Technical bulletin

TB-069

This technical bulletin created for the first and second generation 2.3 and 2.8JTD FIAT engine starter applications.

First Generation Starter Motor

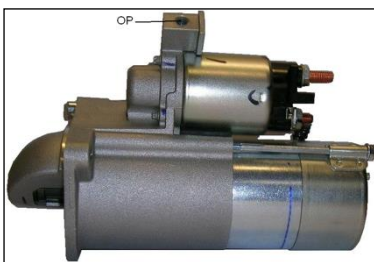
On the first generation 2.3 and 2.8JTD engine Fiat used on the Marelli/Denso: 63114014 and Bosch: 0001218159, 0001223013 0986017020, 0986018960 starters an adaptor flange. The Fiat number of the flange: 1327137080, 1327138080, 5978701

On the second generation engines, Fiat did not use the adaptor flange, that causes the different pinion rest position

The pinion rest position is 24,5mm. The starter is assembled on the engine with an adaptor flange (the pinion rest position with the adaptor flange is same as the position of the new generation starter).

The pinion rest position is 2mm.

Please do not use the adaptor flange, if you have receive the second generation type starter motor!
